North Carolina Building Code Council

February 14, 2020

RE: Agenda for the March 10, 2020 NC Building Code Council Meeting

FIGURE AM105.2
TYPICAL DECK GIRDER SPANS

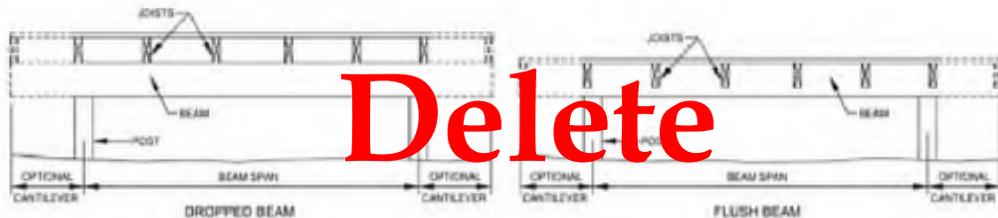
~~**AM105.2 Girder span for uncovered porches and decks.** Maximum allowable spans for wood deck girders, as shown in Figure AM105.2, shall be in accordance with Table AM105.2. Girder plies shall be fastened with two rows of 10d (3-inch × 0.128-inch) nails minimum at 16 inches (406 mm) on center along each edge. Girders shall be permitted to cantilever at each end up to one-fourth of the actual beam span. Splices of multispan beams shall be located at interior post locations.~~

FIGURE AM106.1
TYPICAL DECK JOIST SPANS

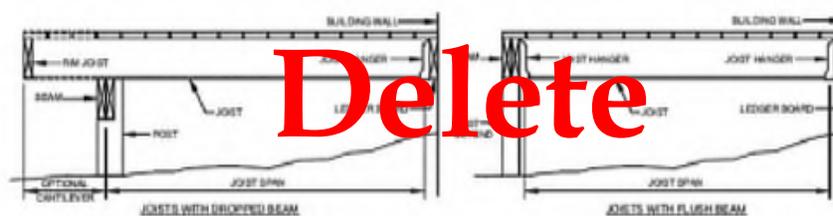
~~**AM106.1 Joist spans for uncovered porches and decks and cantilevers.** Joists spans shall be based upon Table R502.3.1(2) with 40lbs per sq ft of live load and 10 lbs per sq ft of dead load. Floor joists for exterior decks may be cantilevered per Table R502.3.3(1). Maximum allowable spans for wood deck joists, as shown in Figure AM106.1, shall be in accordance with Table AM106.1. Deck joists shall be permitted to cantilever not greater than one-fourth of the actual, adjacent joist span.~~

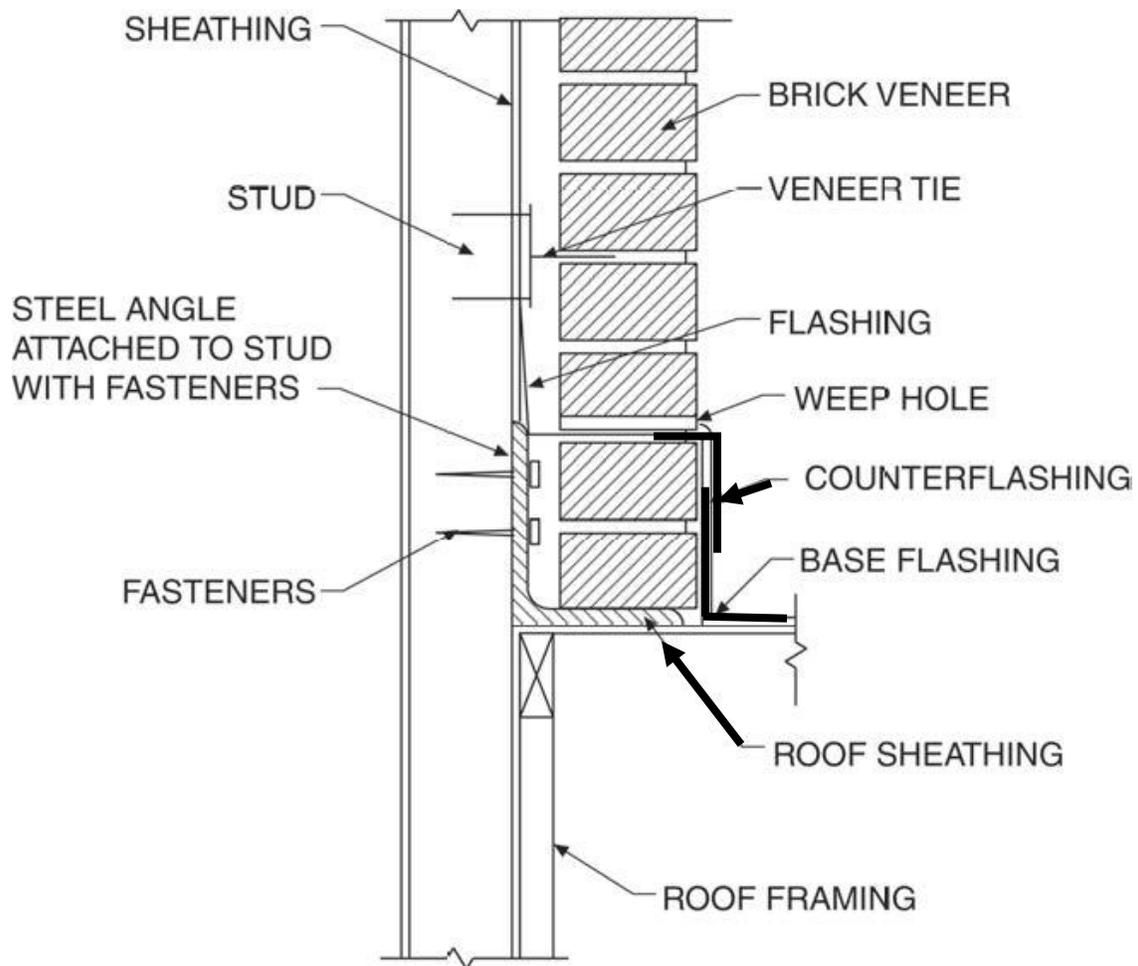
R312.1.3 Opening limitations. Required *guards* shall not have openings from the walking surface to the required *guard* height that allow passage of a sphere 4 inches (102 mm) in diameter.

1. The triangular openings at the open side of stair, formed by the riser, tread and bottom rail of a *guard*, shall not allow passage of a sphere 6 inches (153 mm) in diameter.
2. *Guards* on the open side of stairs shall not have openings that allow passage of a sphere 4 3/8 inches (111 mm) in diameter.
3. The opening between adjacent treads is not limited on stairs with a total rise of 30 inches (762 mm) or less.

FIGURE R703.8.2.2
EXTERIOR MASONRY VENEER SUPPORT BY ROOF MEMBER

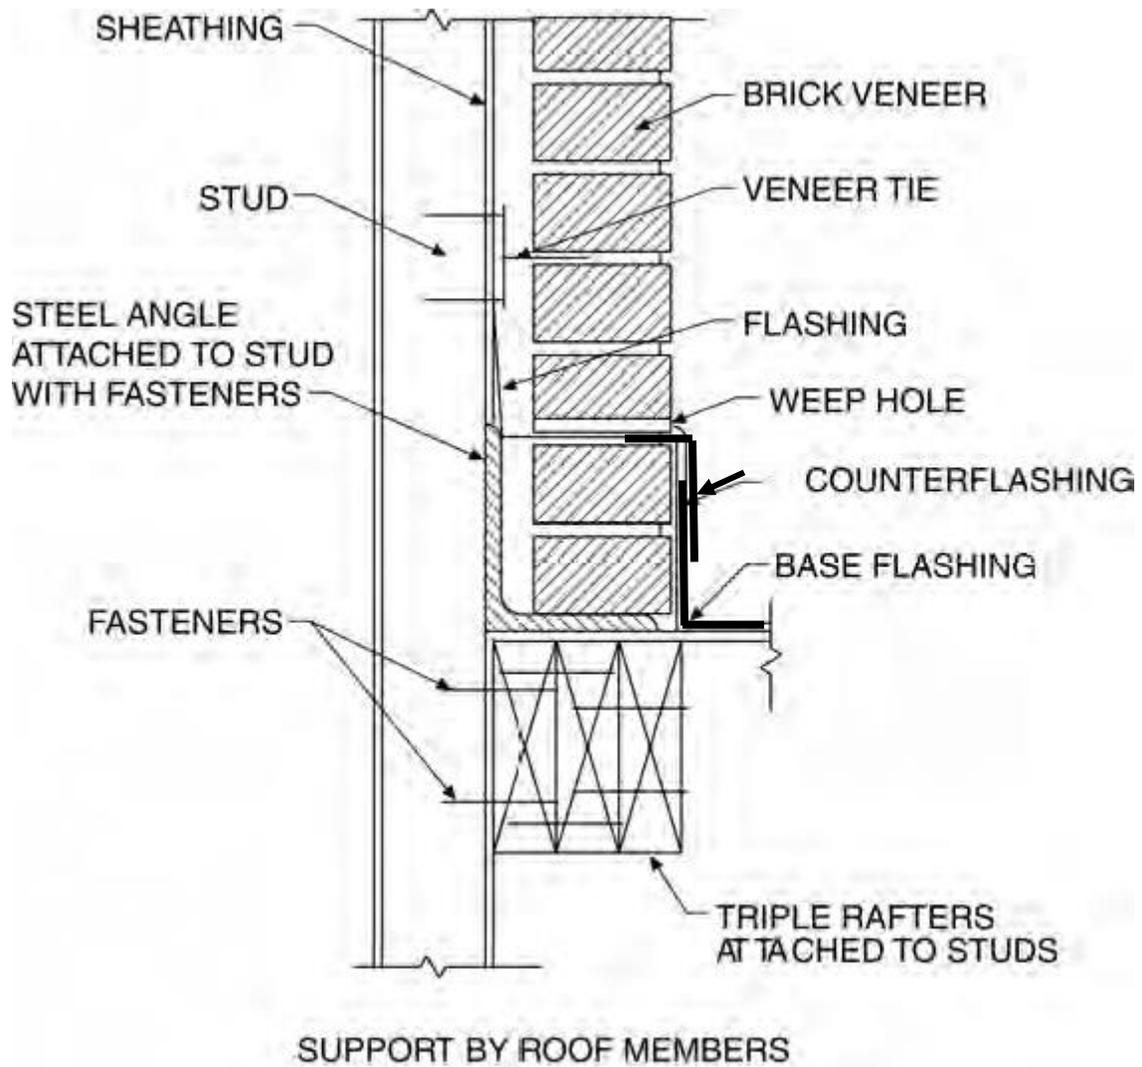
R703.8.2.1 Support by steel angle. A minimum 6-inch by 4-inch by 5/16-inch (152 mm by 102 mm by 8 mm) steel angle, with the long leg placed vertically, shall be anchored to double 2-inch by 4-inch (51 mm by 102 mm) wood studs at a maximum on-center spacing of 16 inches (406 mm). Anchorage of the steel angle at every double stud spacing shall be a minimum of not less than two 7/16-inch diameter (11 mm) by 4-inch (102 mm) lag screws for wood construction at every double stud or shall be a minimum of two 7/16-inch diameter (11.1 mm) by 4 inches (102 mm) lag screws into solid double blocking with each pair of lag screws spaced at horizontal intervals not to exceed 16 inches (406 mm). The steel angle shall have a minimum clearance to underlying construction of 1/16 inch (1.6 mm). ~~Not less than~~ A minimum of two-thirds the width of the masonry veneer thickness shall bear on the steel angle. Flashing and weep holes shall be located in the masonry veneer in accordance with Figure R703.8.2.1. The maximum height of masonry veneer above the steel angle support shall be 12 feet 8 inches (3861 mm). The airspace separating the masonry veneer from the wood backing shall be in accordance with Sections R703.8.4 and R703.8.4.2. The method of support for the masonry veneer on ~~wood construction~~ steel angle shall be constructed in accordance with Figure R703.8.2.1.

The maximum slope of the roof construction without stops shall be 7:12. Roof construction with slopes greater than 7:12 but not more than 12:12 shall have stops of a minimum 3-inch by 3-inch by 1/4-inch (76 mm by 76 mm by 6.4 mm) steel plate welded to the angle at 24 inches (610 mm) on center along the angle or as approved by the building official.

**FIGURE AM109.1(4)
CROSS BRACING**

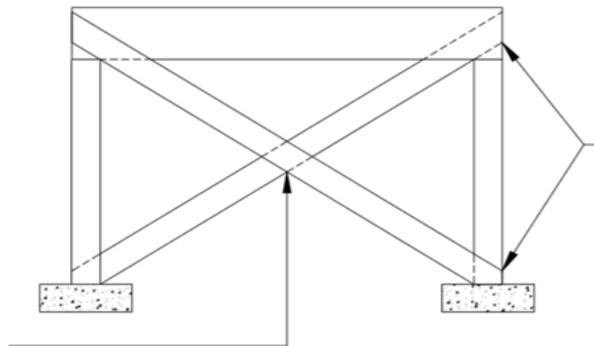
2x6 diagonal vertical cross bracing is permitted to be provided in two perpendicular directions for free standing decks or parallel to the structure at the exterior column line for attached decks. The 2x6 bracing shall be attached to the posts with one of the methods in Table AM109.1.4 ~~5/8-inch (16 mm) hot dip galvanized bolt with nut and washer~~ at each end of each bracing member in accordance with Figure AM109.1(4).

IF SPAN BETWEEN POSTS IS GREATER THAN 7', CENTER BLOCKING AND ONE 5/8" BOLT WITH NUT AND WASHER—WITH FASTENER(S) PER TABLE AM109.4 REQUIRED

ONE 5/8" BOLT TOP AND BOTTOM END WITH A NUT AND WASHER. FASTENER PER TABLE AM109.1.4
